ADDENDUM NUMBER 2

PROJECT: **Ke-nek Water Treatment Plant and Water Main**

PROJECT NUMBER: **CA 21-F05**

OWNER: **Yurok Tribe**

KE-NEK WATER TREATMENT PLANT
AND KE-NEK WATER MAIN
PLAN VIEW, UPPER ACCESS ROAD

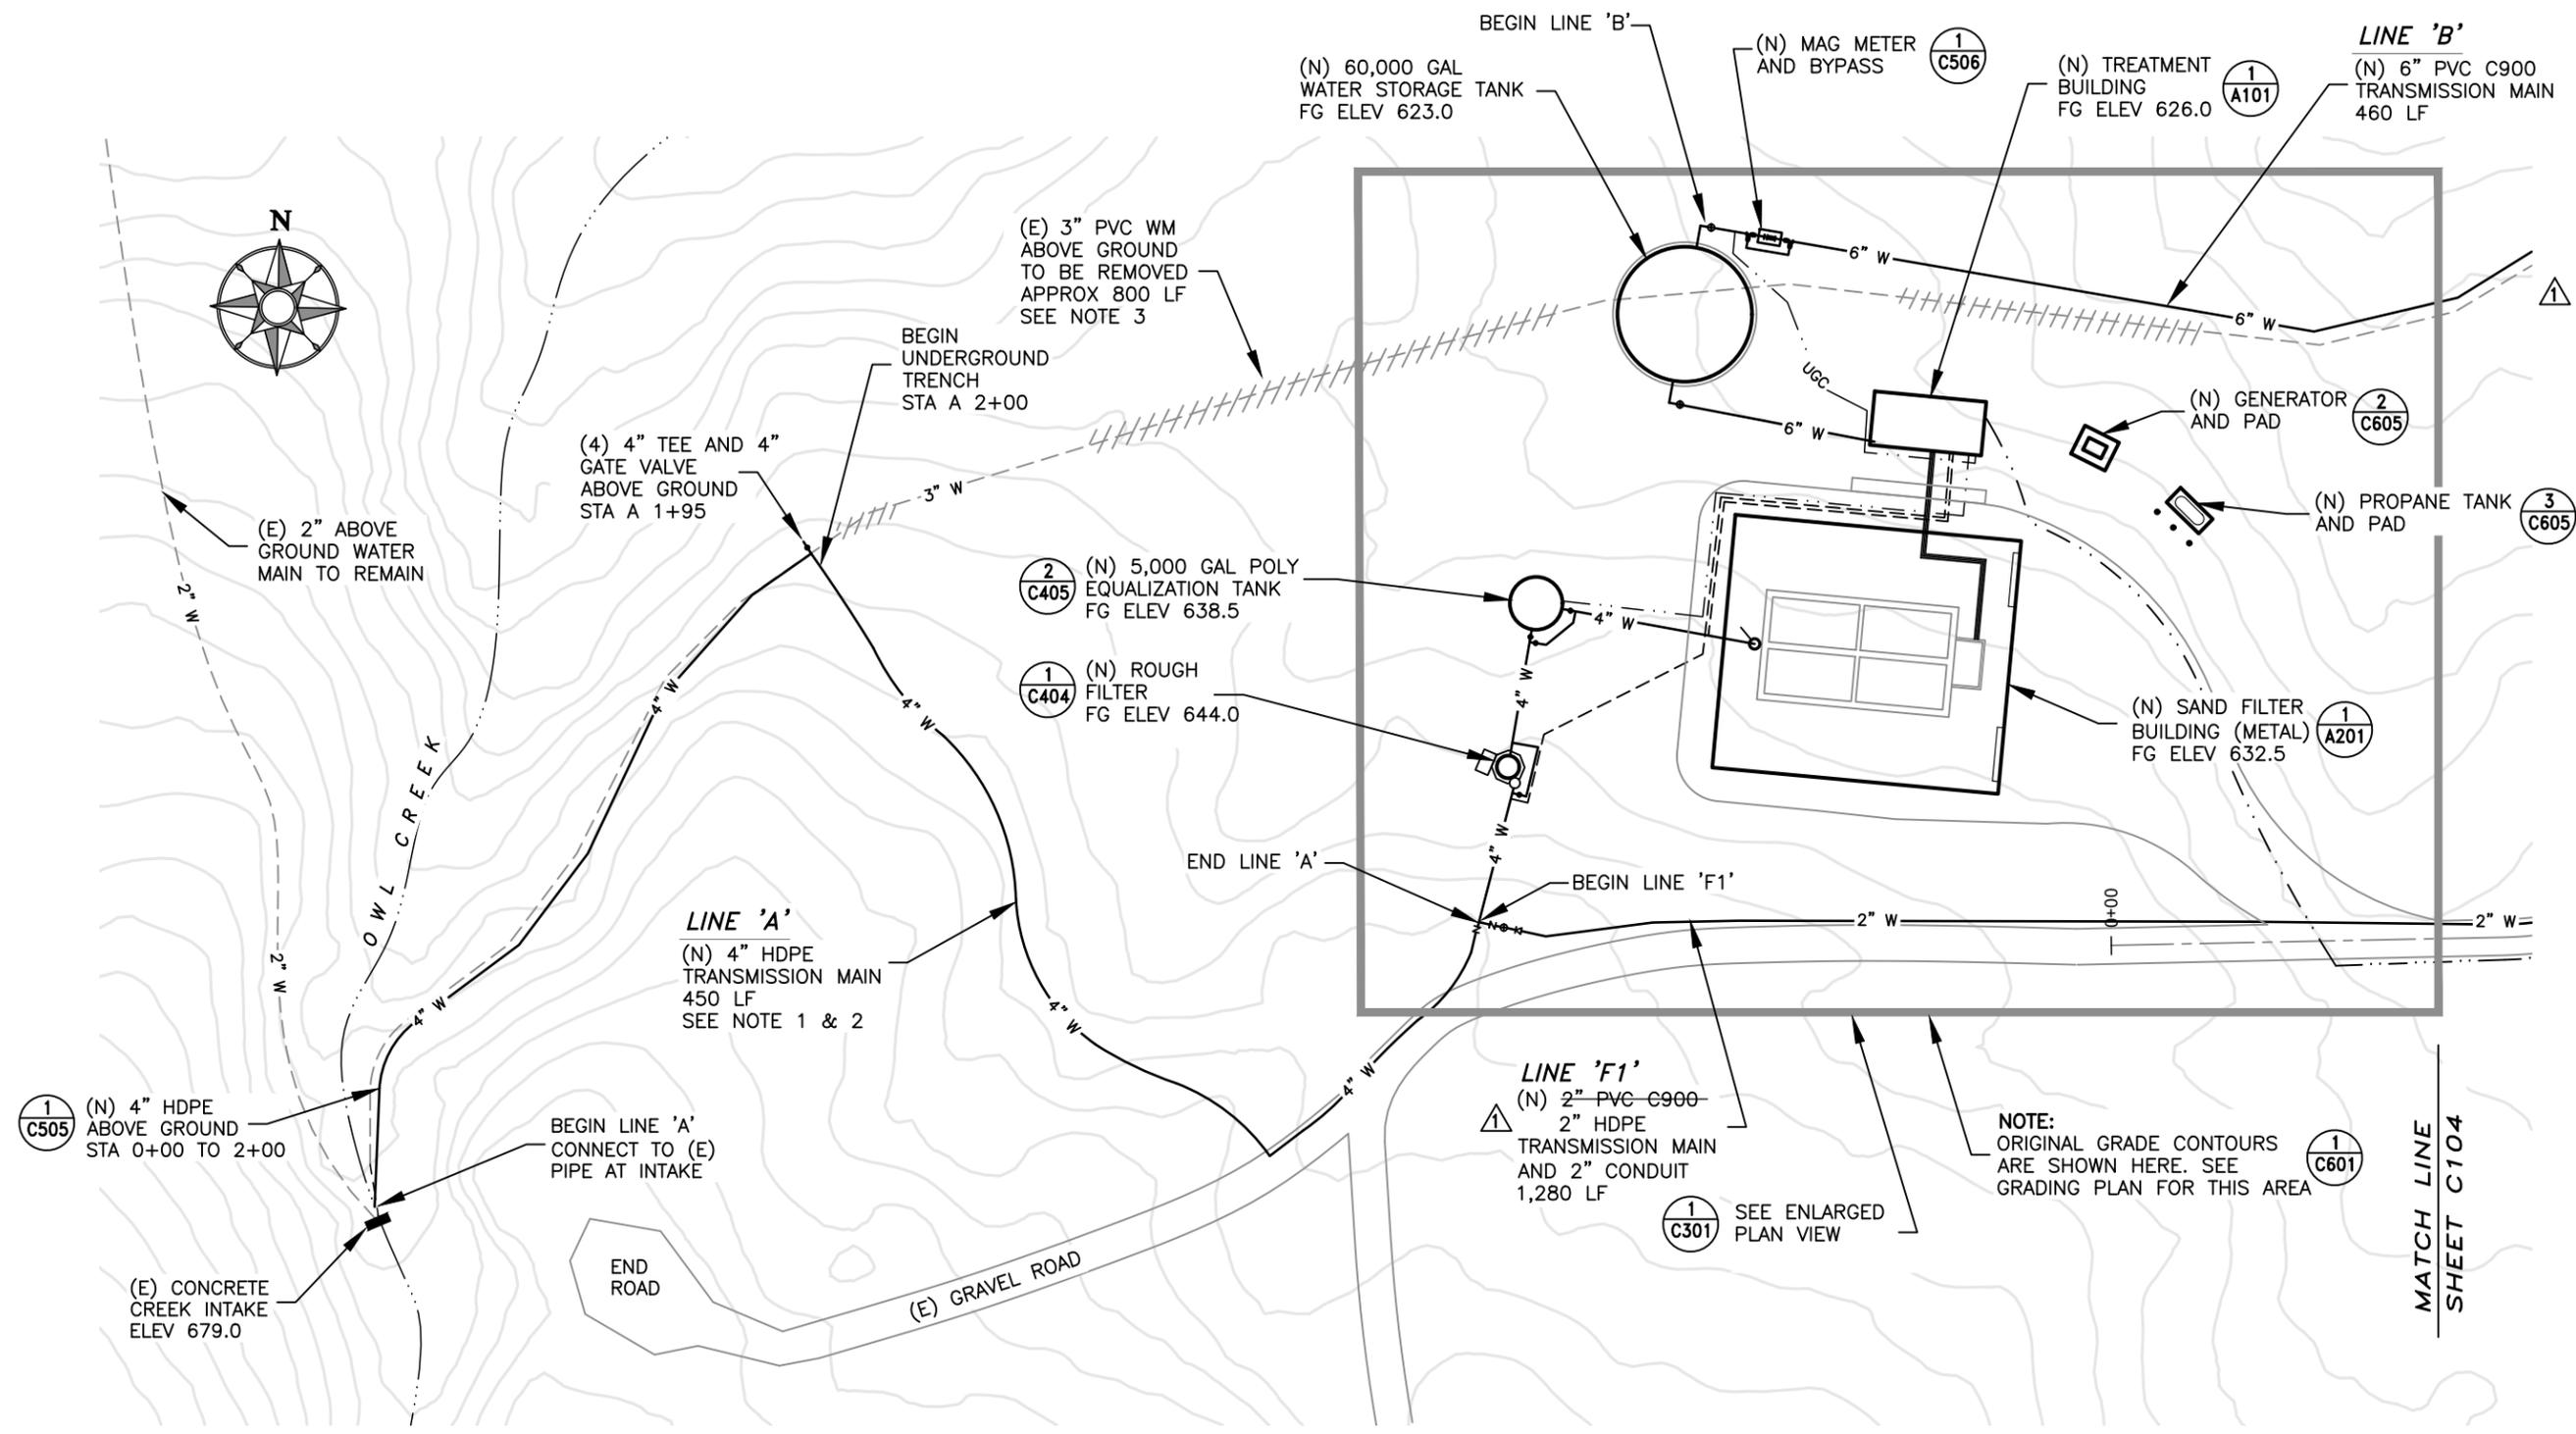
DRAWING C102 – Plan view, Upper Access Road

Line F1 – 2” PVC C900 changed to 2” HDPE

Reference to detail 3/C505 on “Line A” removed – the tee and gate valve will be above ground.

Added Note 3

KE-NEK WATER TREATMENT PLANT AND KE-NEK WATER MAIN
PLAN & PROFILE, ACCESS ROAD

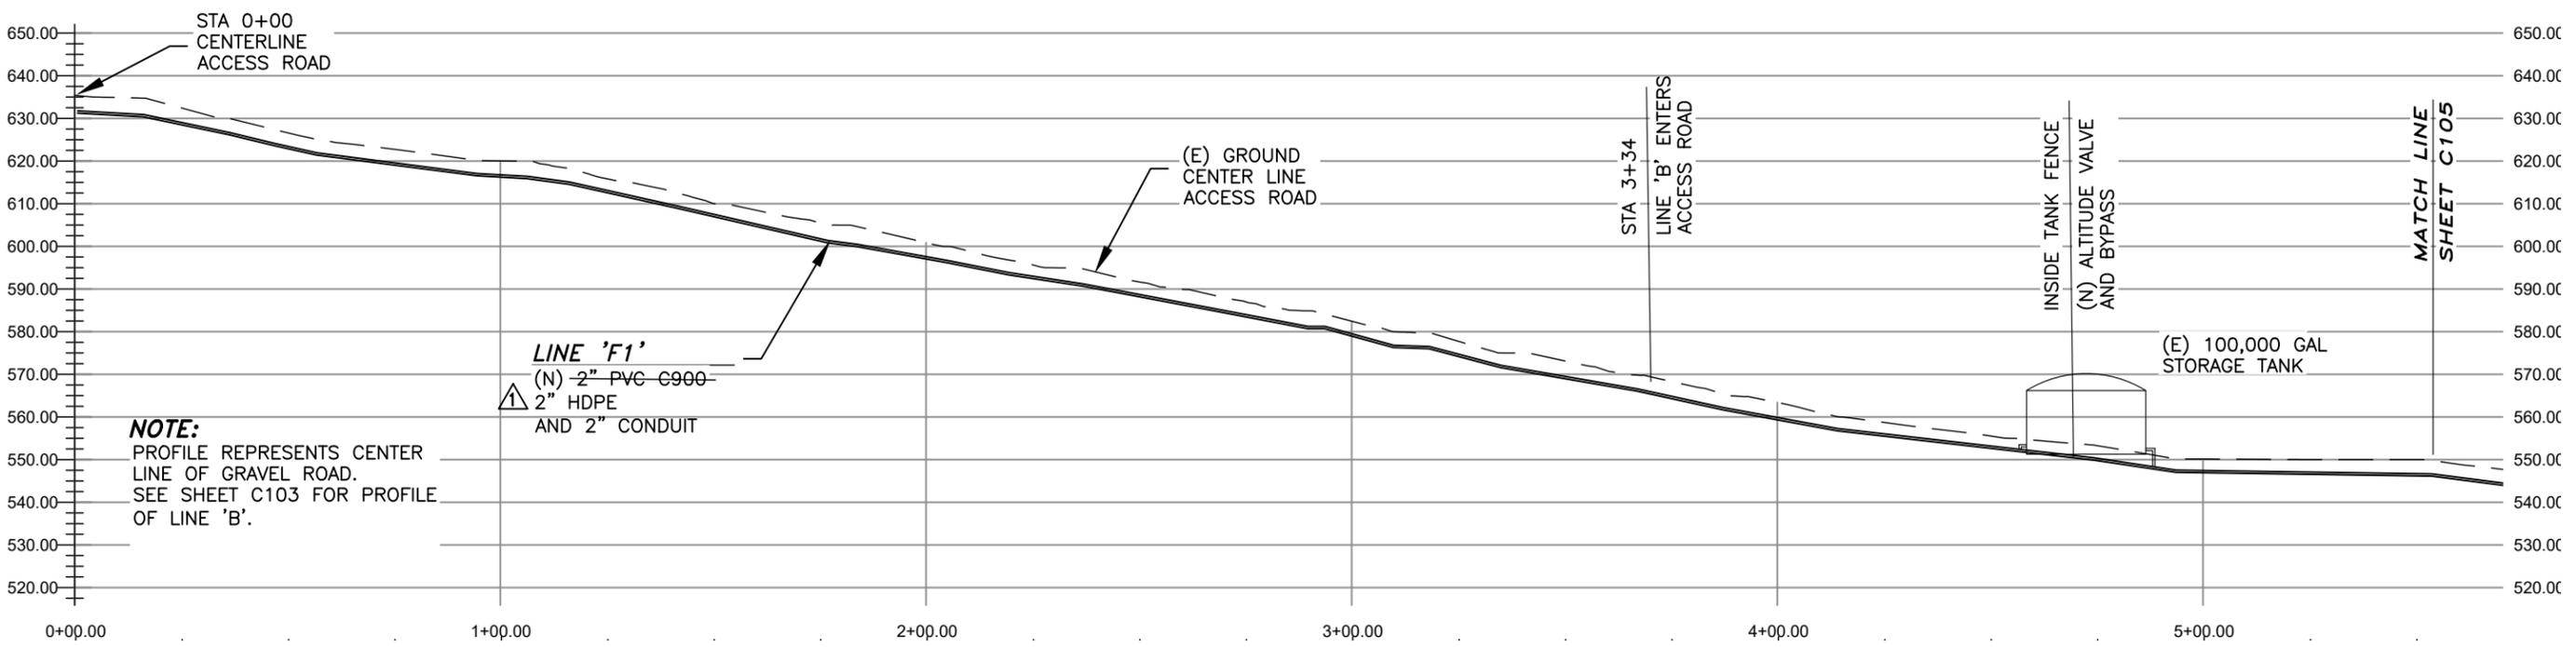
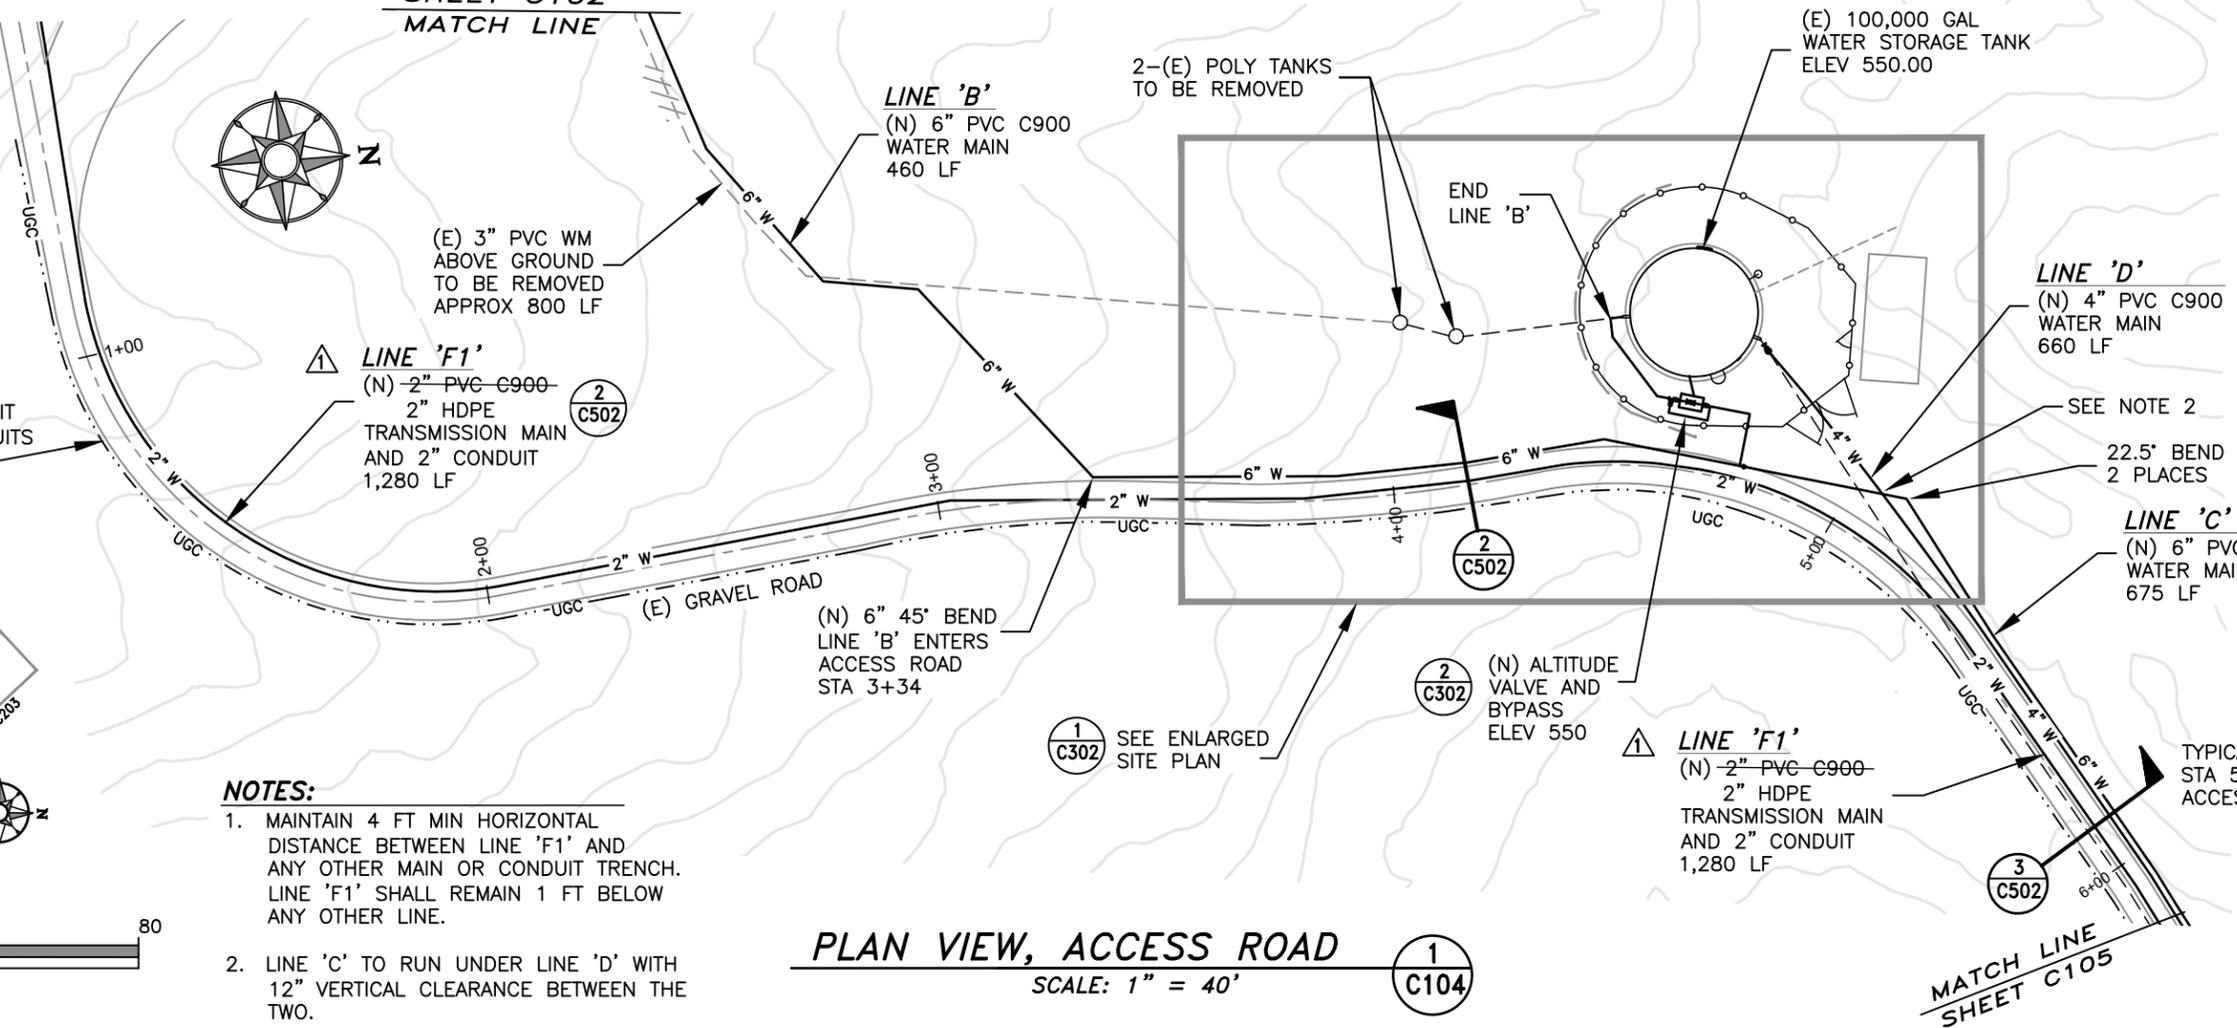
DRAWING C104 – Plan & Profile, Access Road

Line F1 – 2” PVC C900 changed to 2” HDPE, 3 places.
